SUBJECT: Council Submission to the Western Harbour Tunnel and Warringah Freeway Upgrade Environmental Impact Statement

**SUBMISSION FROM NORTH SYDNEY COUNCIL TO THE
DEPARTMENT OF PLANNING, INDUSTRY AND ENVIRONMENT
WESTERN HARBOUR TUNNEL AND WARRINGAH FREEWAY
UPGRADE ENVIRONMENTAL IMPACT STATEMENT
MARCH 2020**

Figure 6 – Land bridge concept

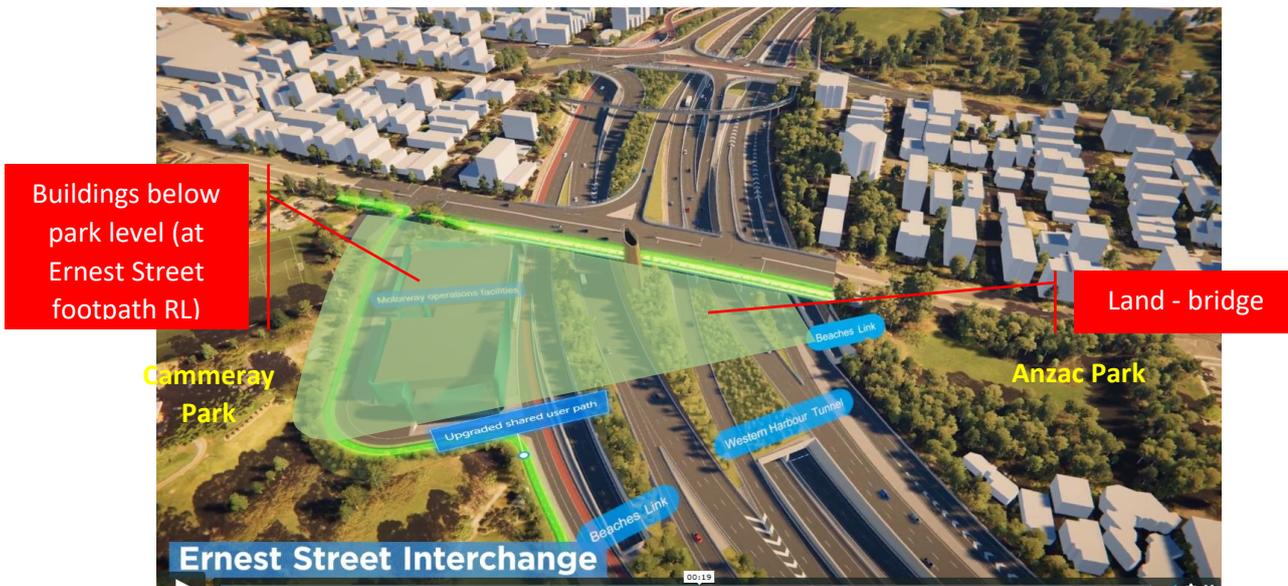
2. That a substantial land-bridge be constructed linking the south west corner of Cammeray Park with the western side of Anzac Park. The scheme in the EIS proposes a narrow green 'median' only as part of the 'shared user path' section of the reconstructed Ernest Street bridge. Rather, the land-bridge should seek to create a generous reconnection of open space parcels that were severed by the construction of the Warringah Freeway in the 1960s. Both of the above are conceptually illustrated below:

Figure 7 - Land bridge concept and suggested treatments

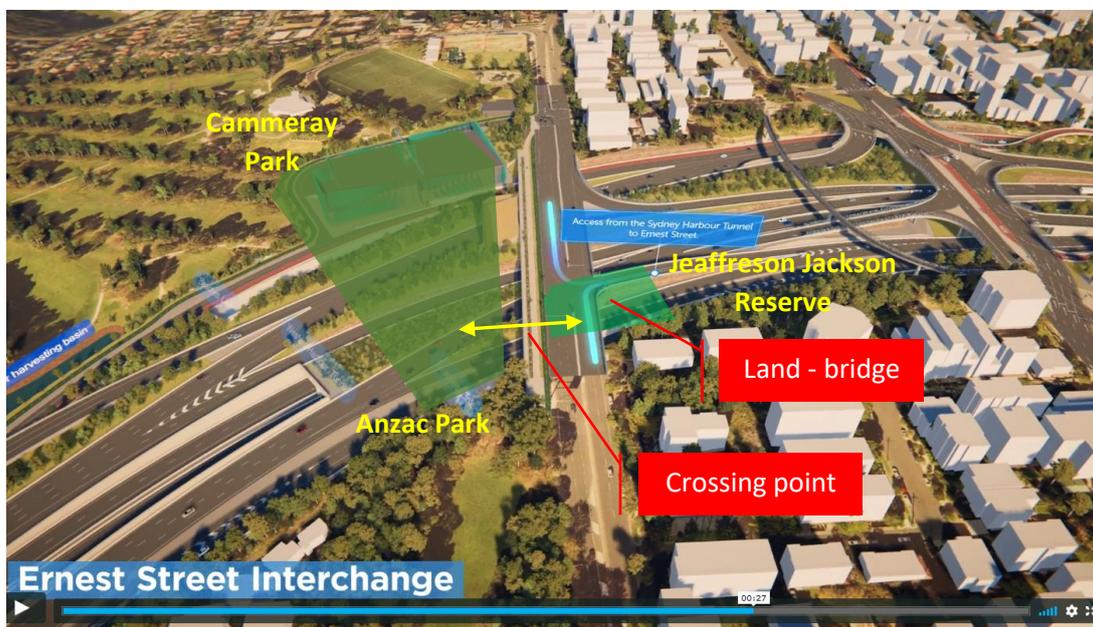
3. That a further, smaller section of land-bridge be established if feasible where the Ernest Street off-ramp joins Ernest Street linking to the existing open space along the western side of the corridor, and a crossing point be established across Ernest Street at this point to the new land-bridge. This will assist to facilitate continuous pedestrian & open space corridor through to Jeaffreson Jackson Reserve to the south and towards St Leonards Park, as illustrated below:

Figure 9 - Location plan of acquisition sites – Morden and Bellevue Streets Cammeray

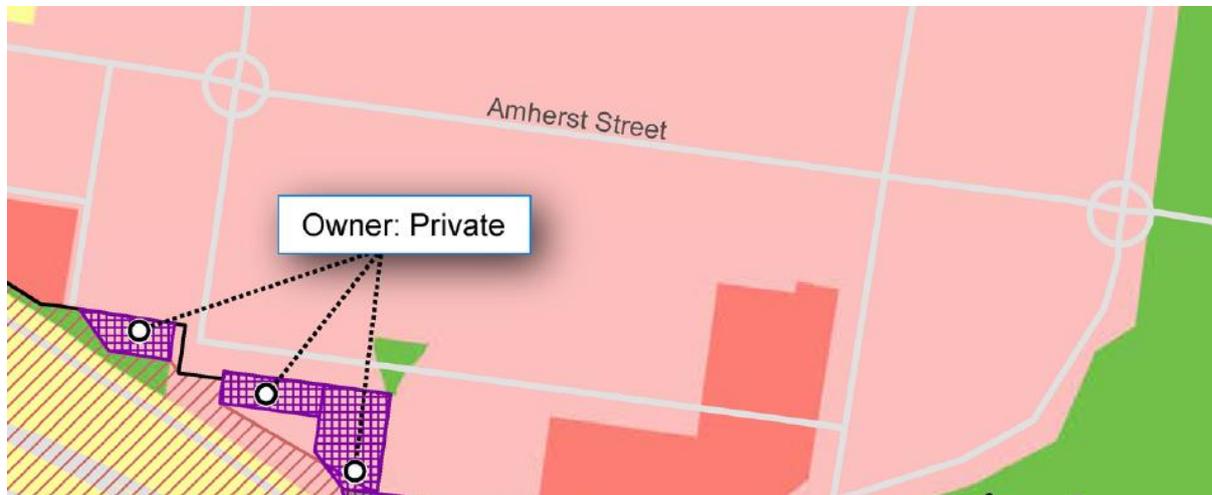
Morden and Bellevue Street properties - Detailed addresses (Lots/DP descriptions) are not provided in the EIS, however, a location plan and description are provided below.

A residential flat building comprising twelve (12) units on Morden Street at Cammeray would be fully acquired and demolished for use during construction. Following construction, the site would be re-habilitated with an undetermined future use and ownership.

Figure 11 - Existing & Proposed Noise Barriers - WHT EIS Appendix G (Part 1), pages. 536-538.

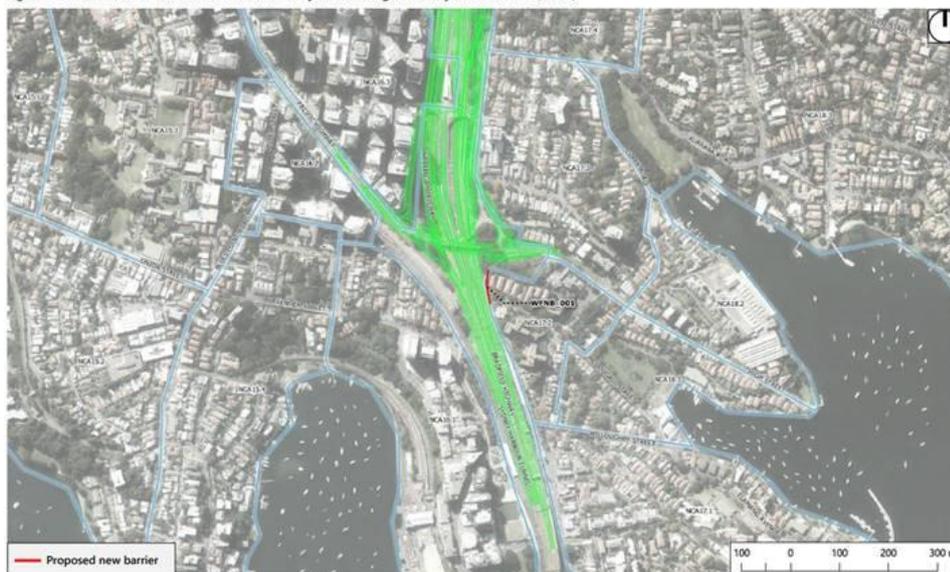
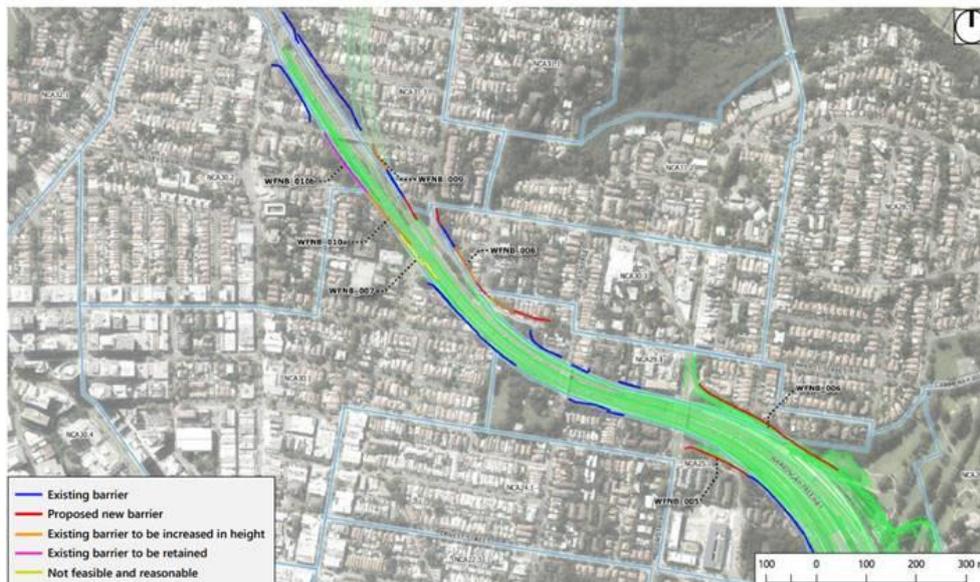
Further assessment has been conducted to compare the ‘Do minimum’ and the ‘Do something cumulative’ scenarios, including proposed low noise pavement and proposed new and existing extended noise barriers.

Figure 1: Identifies the proposed sites to be acquired within Anzac Park for “temporary construction leases”.

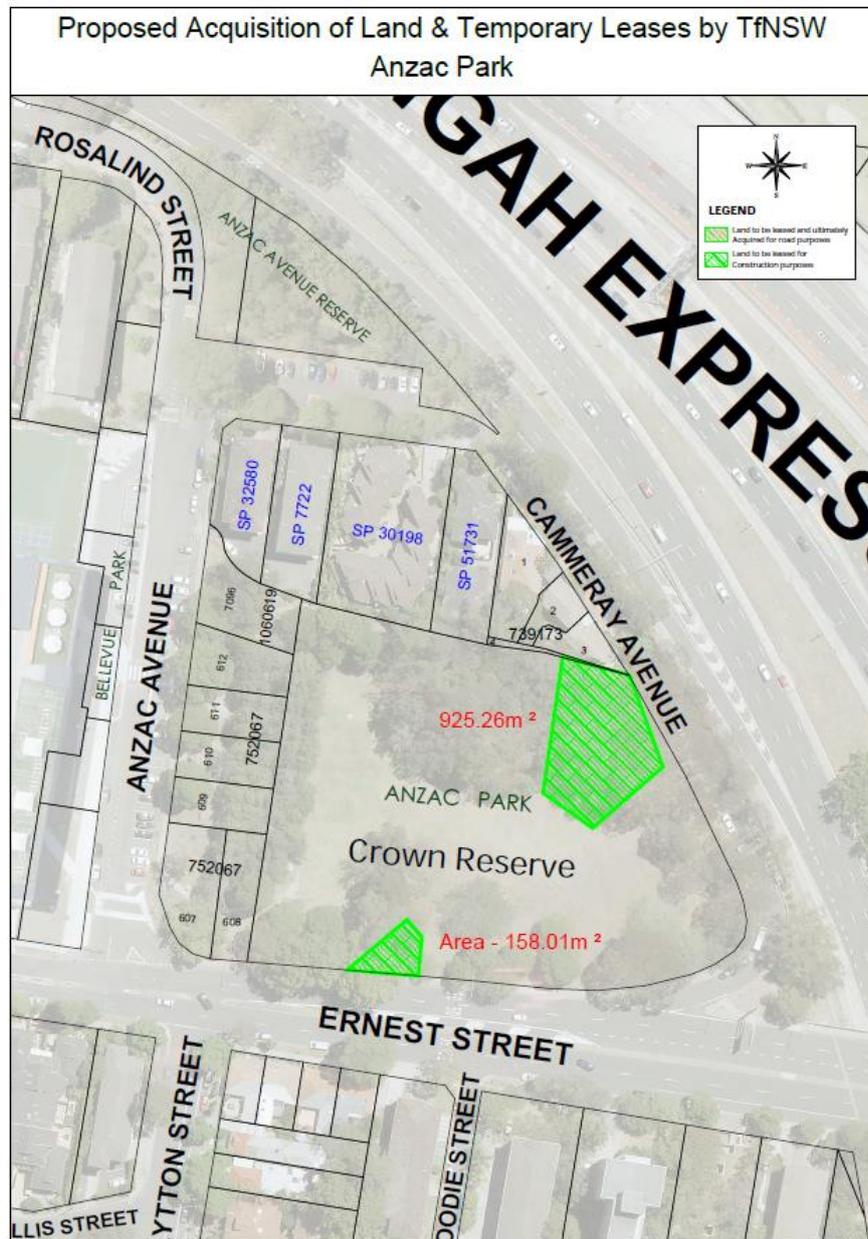
Parcels to be acquired - Refer to *Figure 1* above.

Two (2) parcels are being proposed for the acquisition of temporary construction leases (indicated by Green hatching on *Figure 2*).

Figure 2: Identifies the proposed sites within St Leonards Park for “temporary construction leases”

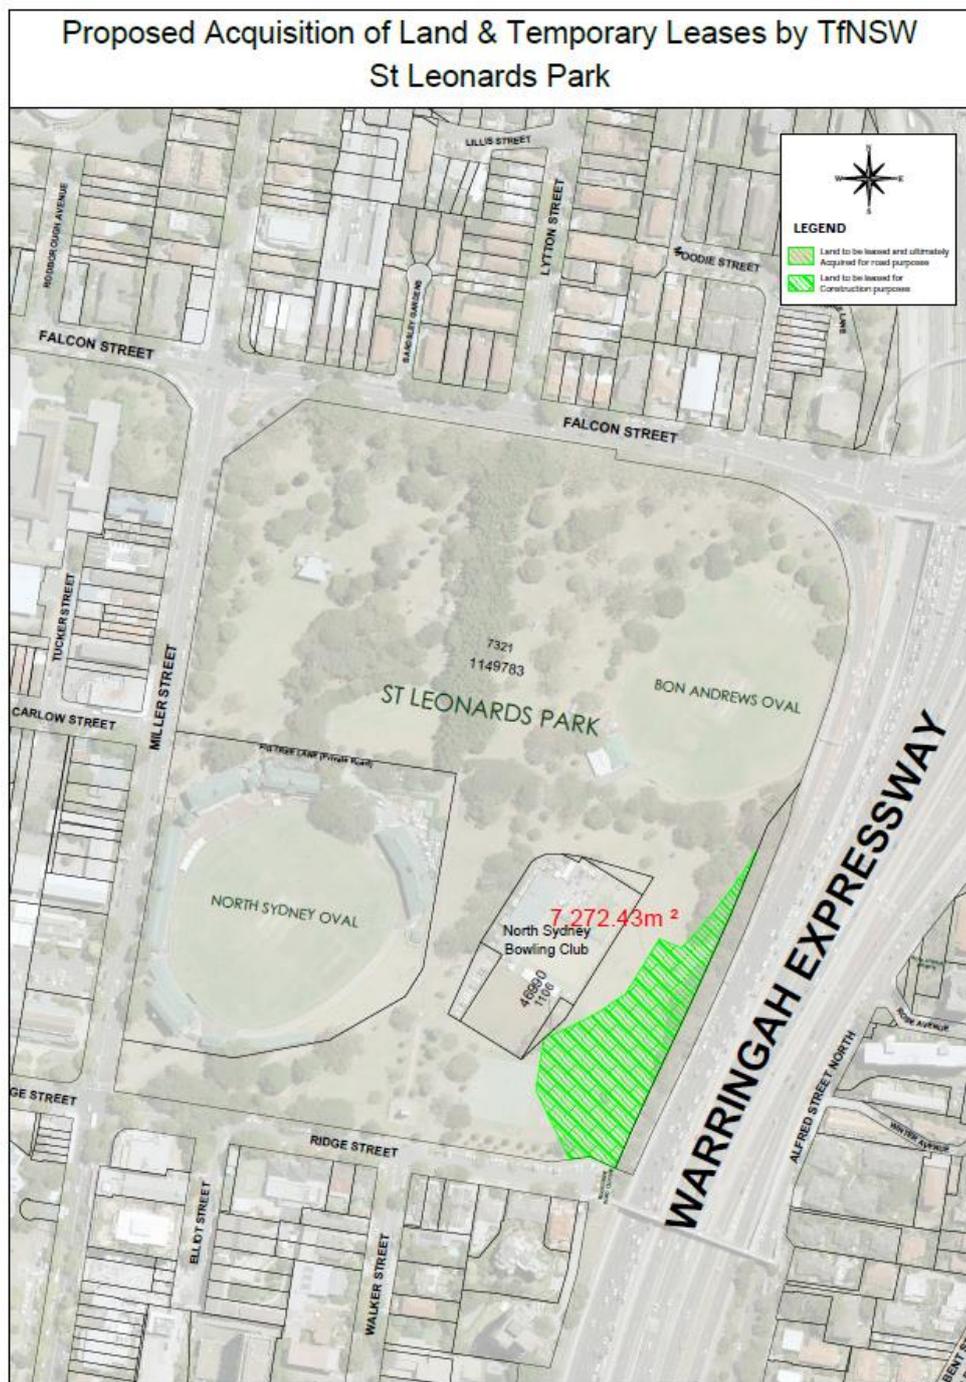
Parcels to be acquired - Refer *Figure 2, above*.

One (1) large parcel is being proposed for the acquisition of a temporary construction lease (indicated by Green hatching on *Figure 2*).

Figure 4 – Aerial view of Cammeray Park which is to be viewed together with Figure 7. The map outlines the water recycling plant and the dam which is used water recycling purposes.

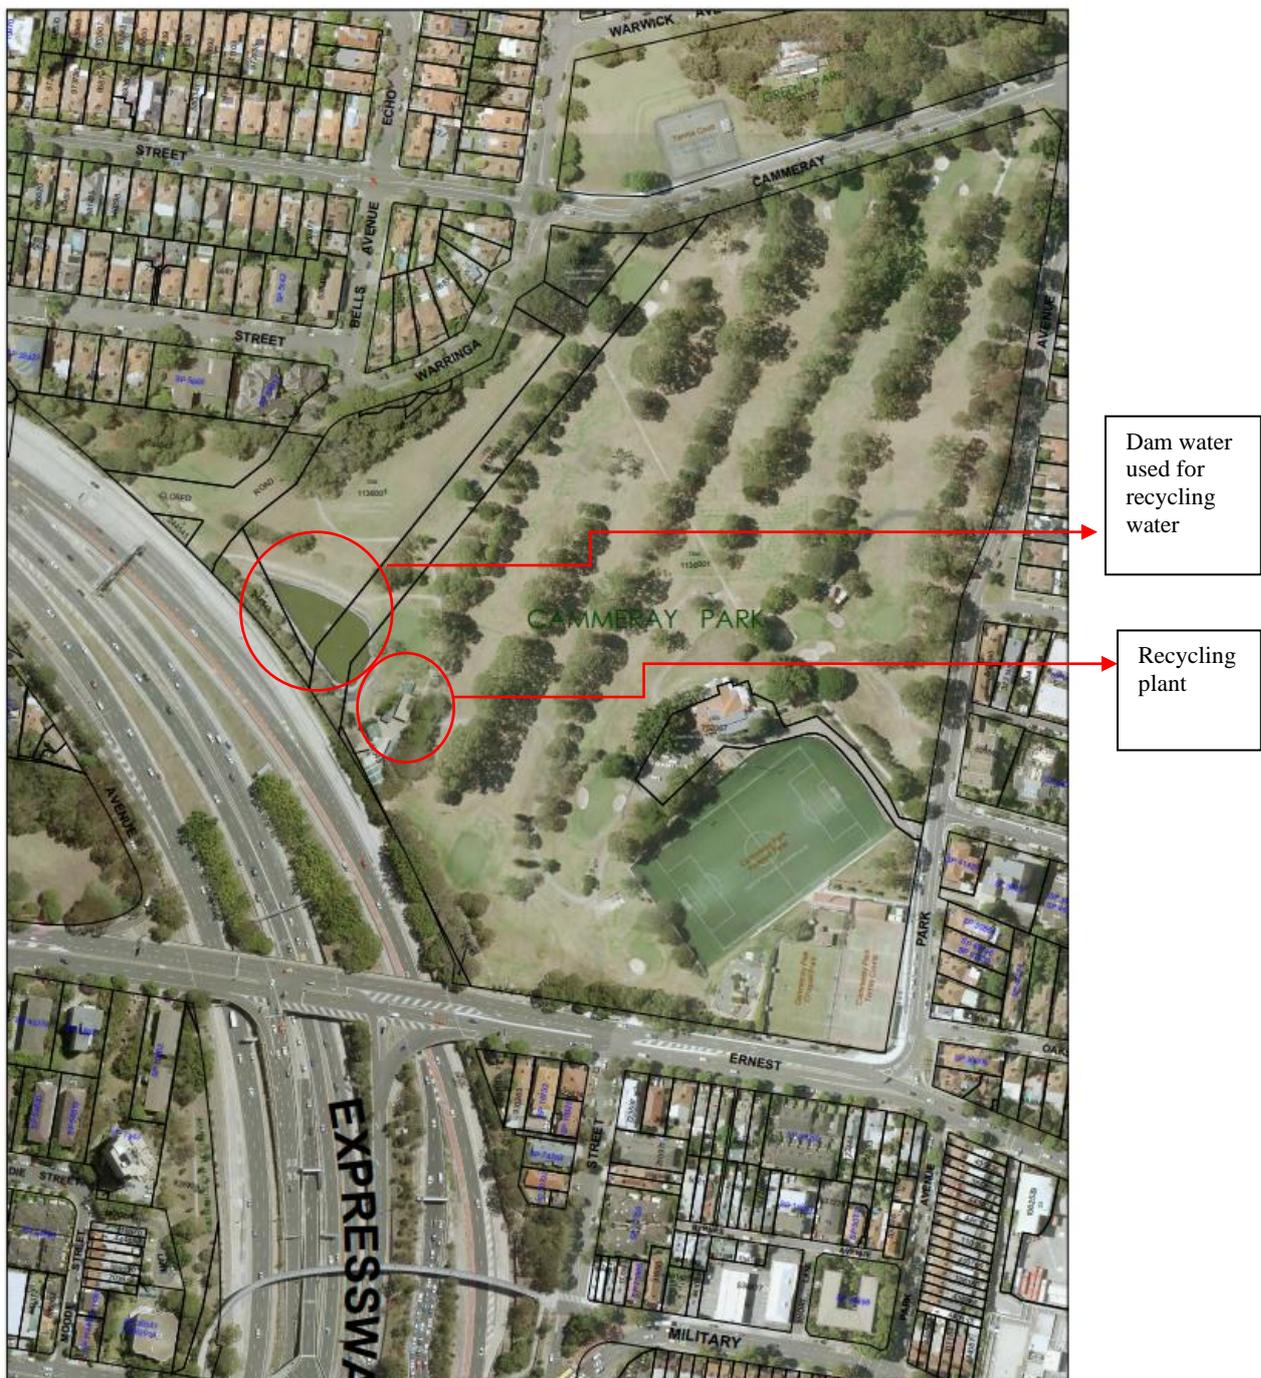
- (a) Approximately 19,290.79m² in total is required for the purposes of *temporary construction leases*. (indicated by green hatching Figure 4).
- (b) Approximately 28,896.47m² in total is required for the *compulsory acquisition* (indicated by Pink colouring with Green hatching on Figure 4).

Each lot which is being affected by the proposal is summarised in the table below and is also reflected in Figure 4.
